ADDENDUM NO. 2

DATE: February 24, 2023

RE: Dickinson Park Sports Fields Renovations
Project No.: 21-1558

Drawings: (all revisions have been clouded and tagged with a delta-2)

FIRST & SECOND FLOOR - FRAMING & FOUNDATION PLANS

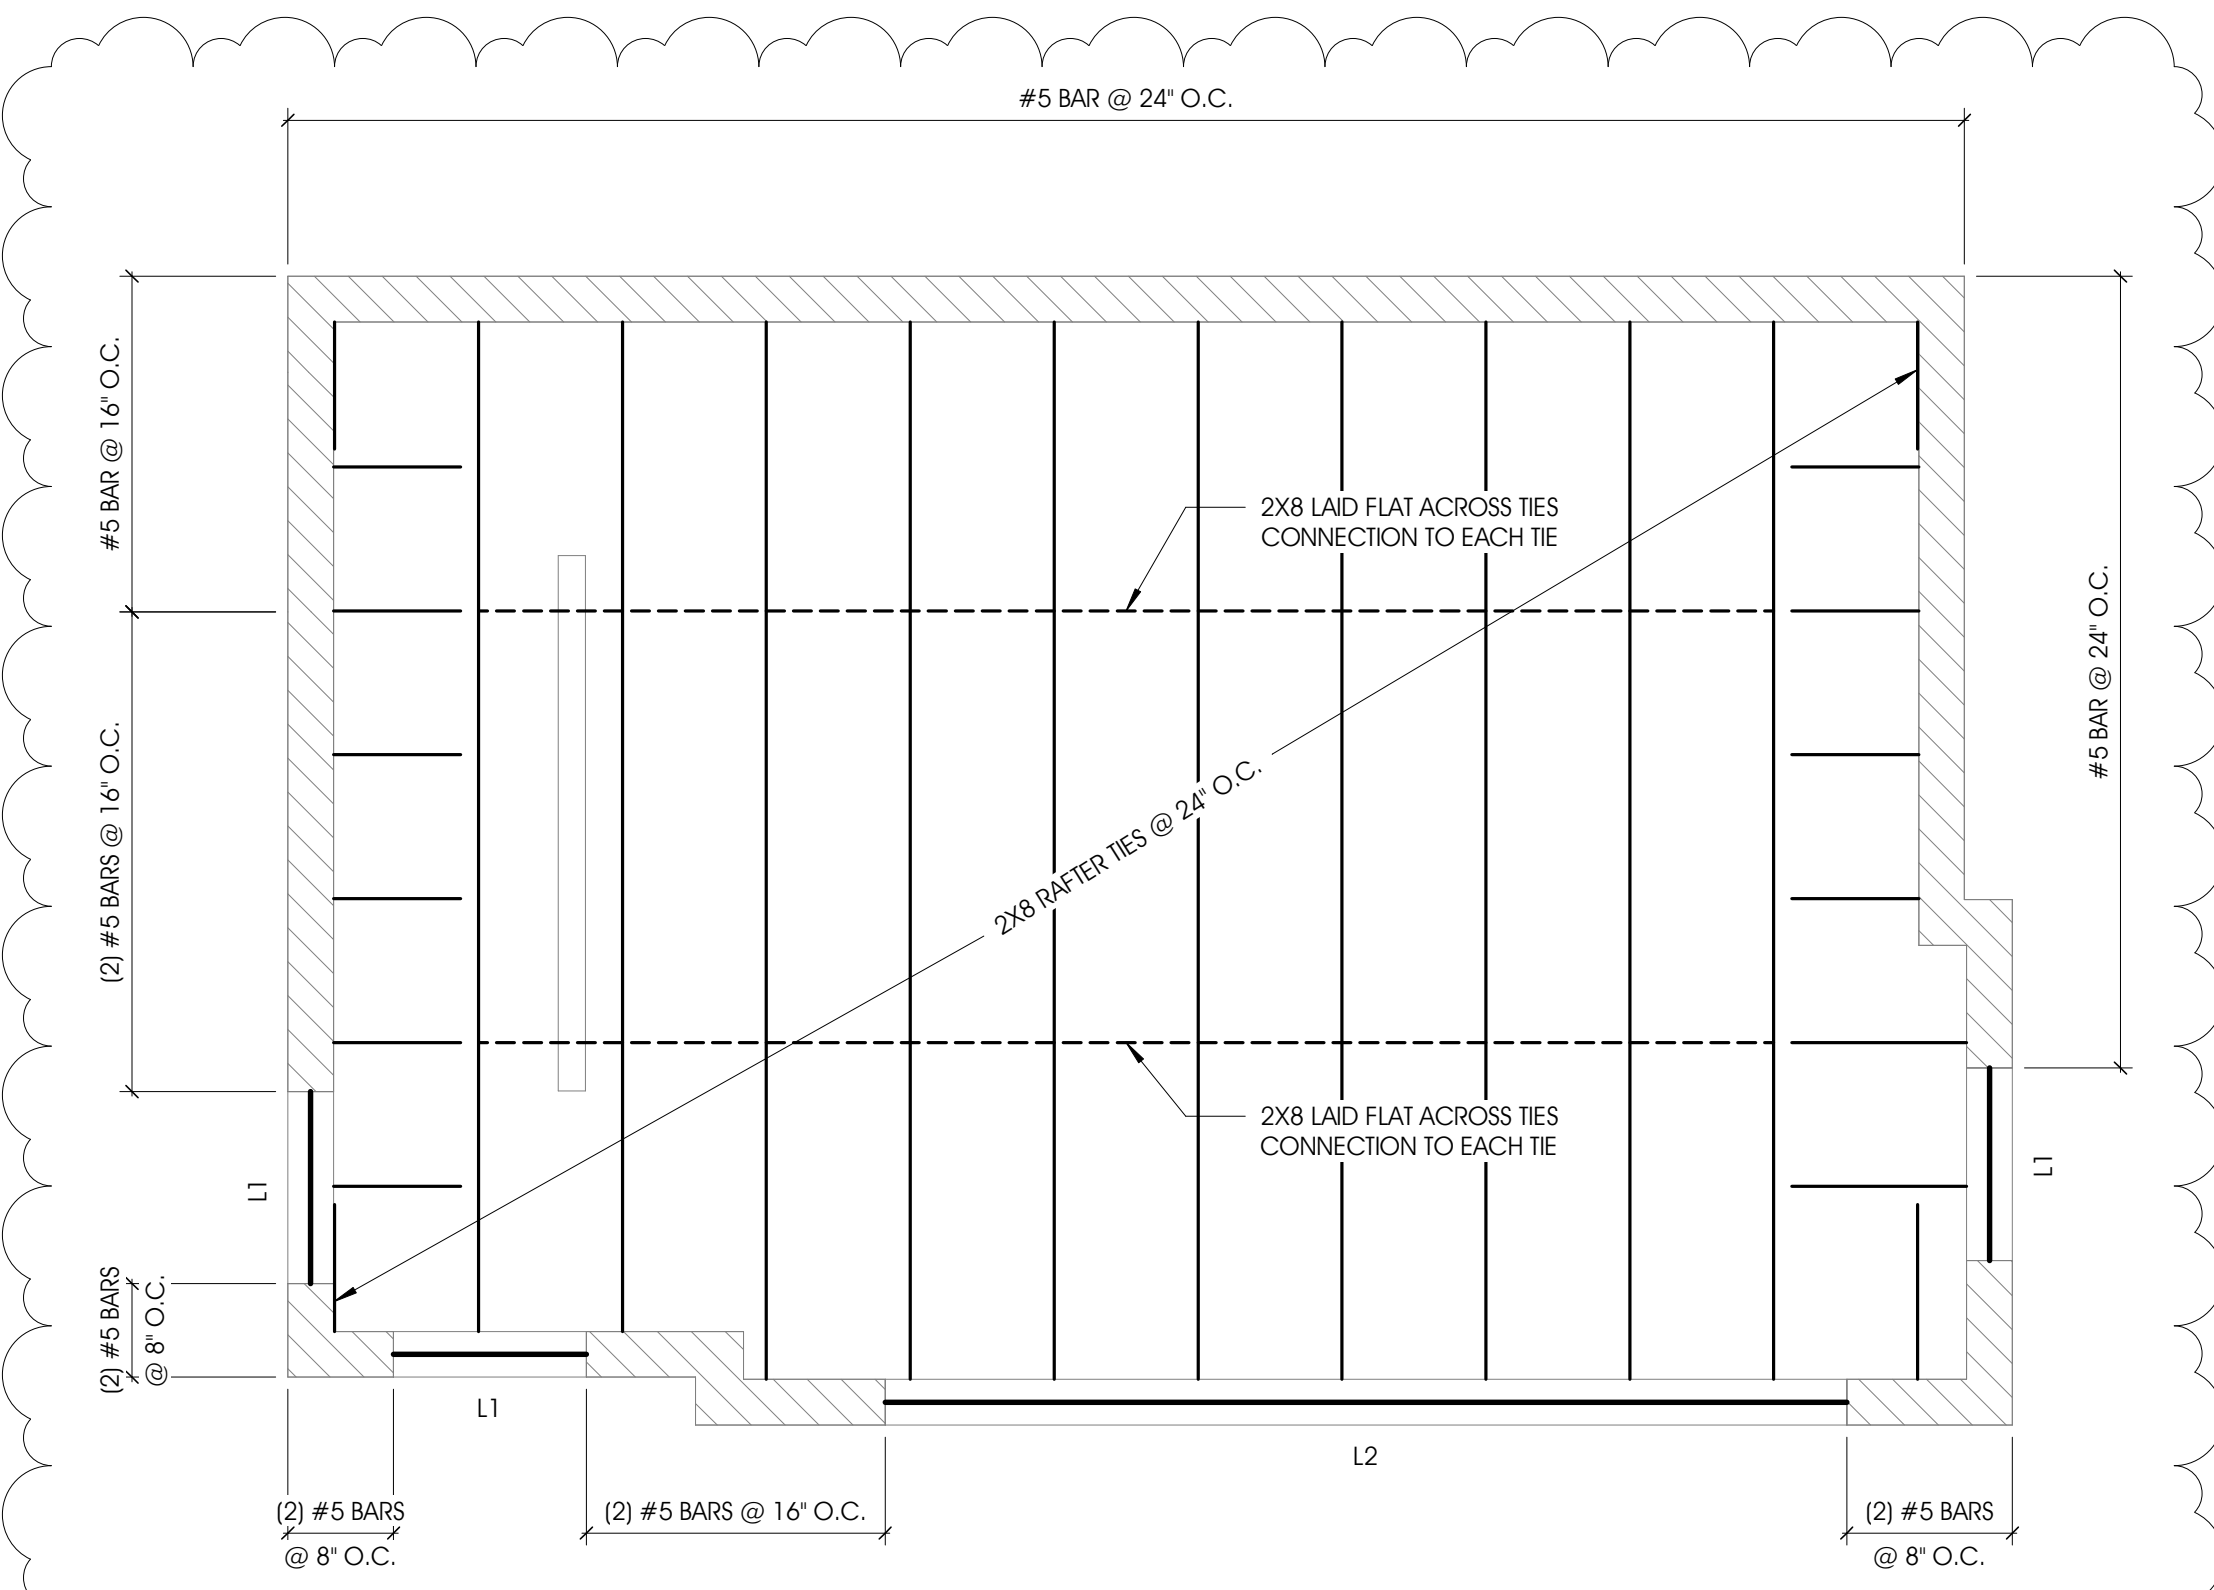
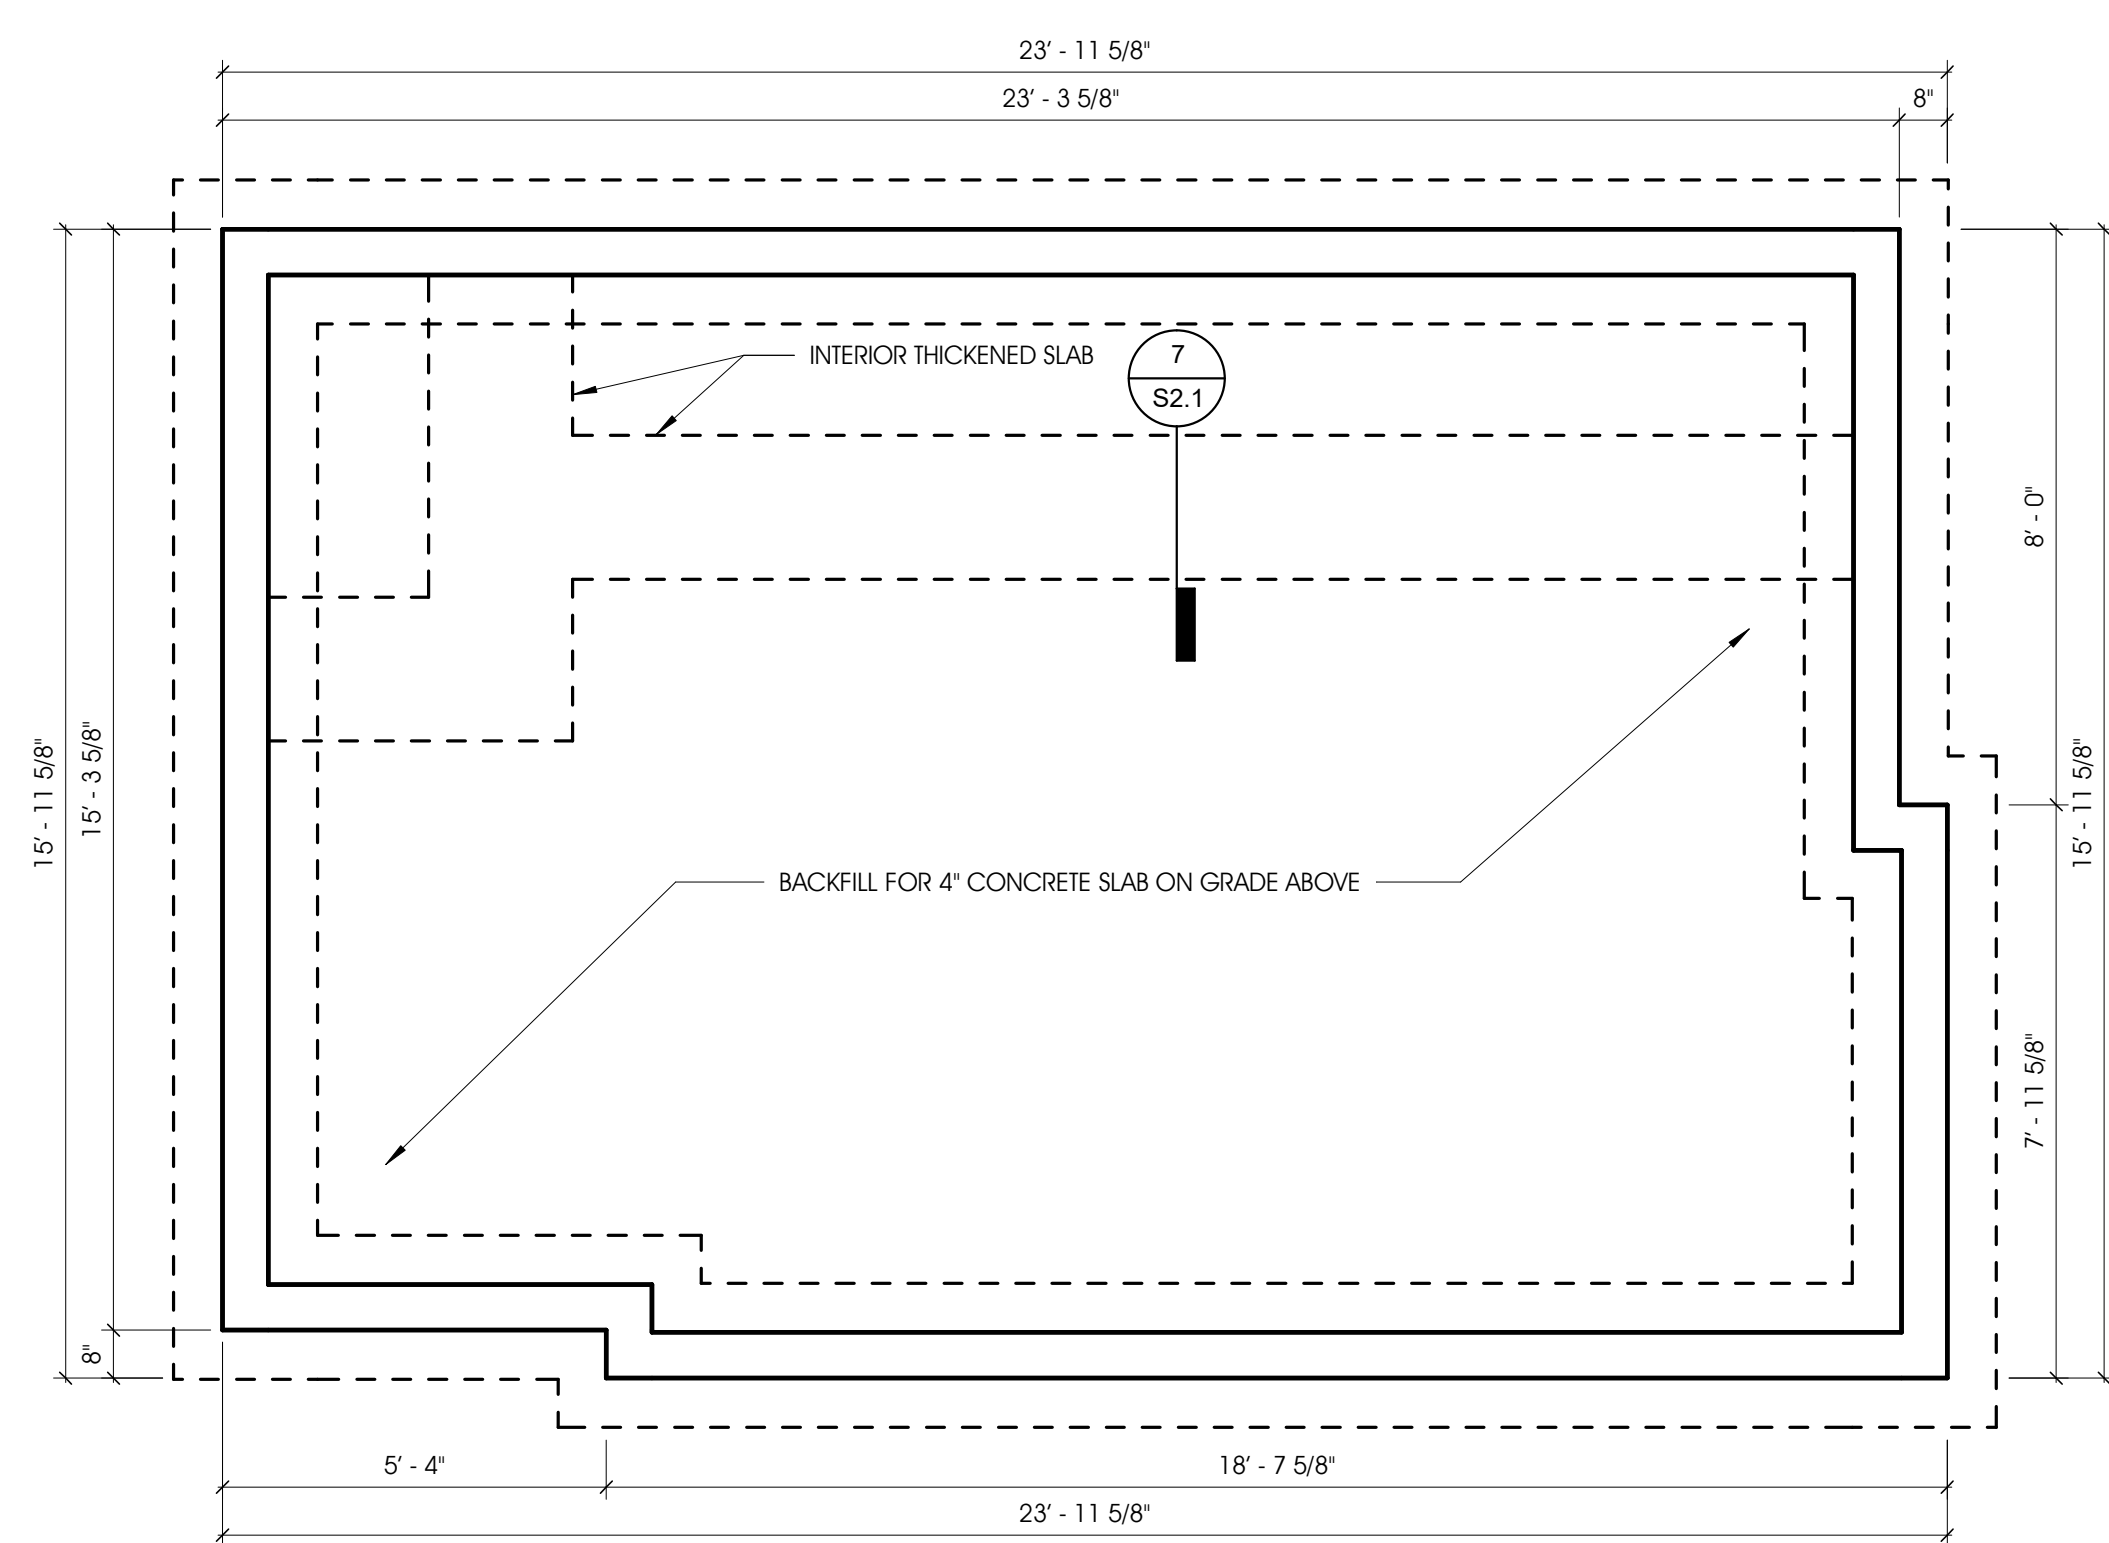
- a. Moved Typical Foundation Detail, Typical Lintel Bearing Detail, and Typical Thickened Slab Detail to Sheet S2.1.
 - b. Added Ceiling Plan.
 - c. Added various Detail-Section tags and notes (see revision bubbles).

- d. Added Lintel Sections detail drawings.
 - e. Minor revisions to General Notes C and F.
13. Alternate 1, Sheet S2.1
- a. Added Sheet S2.1; previously omitted by error
